2016 Ford Mustang V8-5.0L

TSB 15-0144	CLIMATE CONTROLLED SEATS - LACK OF COOLING - FRONT SEAT BACKREST
Publication Date: September 22, 2015

Figure 1 - 15-0144

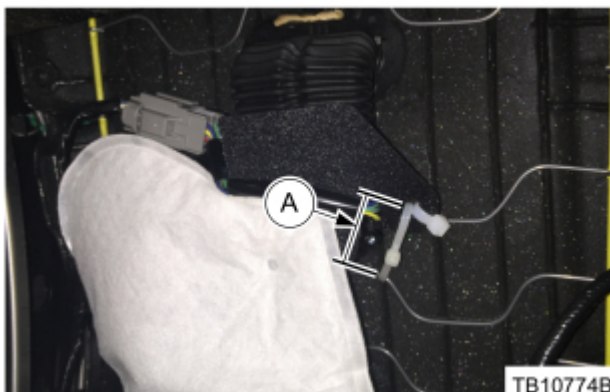
1. Perform the procedure on both seats.
2. Does the vehicle exhibit a lack of cooling from the front seat backrest when using the climate controlled seat?
 - a. Yes - proceed to Step 3.
 - b. No - this article does not apply. Refer to Workshop Manual (WSM), Section 501-10 for normal diagnostics.
3. Can the front seat backrest blower motor be heard running when using the climate controlled seats?
 - a. Yes - proceed to Step 4.
 - b. No - this article does not apply. Refer to WSM, Section 501-10 for normal diagnostics.
4. Remove the front seat backrest blower motor. Refer to WSM, Section 501-10.
5. Install a new front seat backrest blower motor. Refer to WSM, Section 501-10.
 - a. Secure the new front seat backrest blower motor with a tie strap leaving 25 mm (1 inch) of slack in the tie strap. (Figure 1A)

Figure 2 - 15-0144

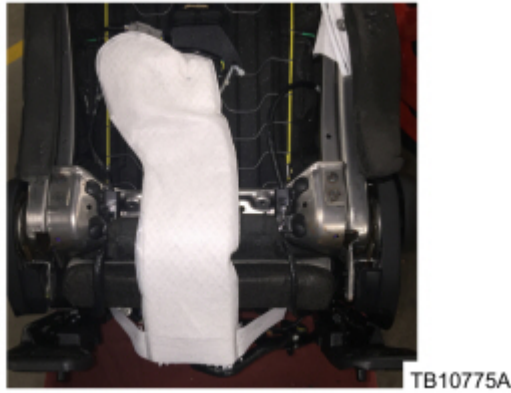
b. Route the air intake snorkel of the new blower motor as shown. (Figure 2)

Figure 3 - 15-0144

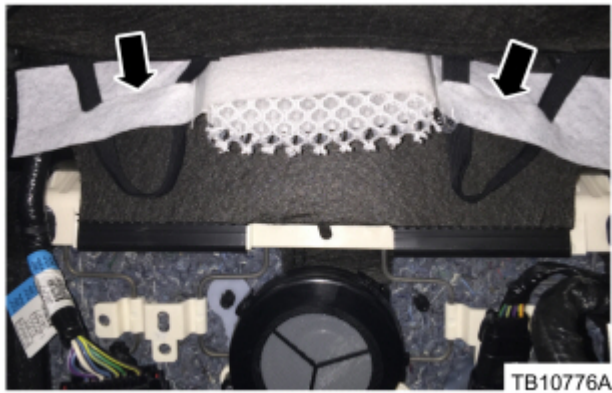
a. Route the elastic backrest cover straps through the slots in the fabric at the end of the air intake snorkel prior to refastening the elastic backrest cover straps. (Figure 3)
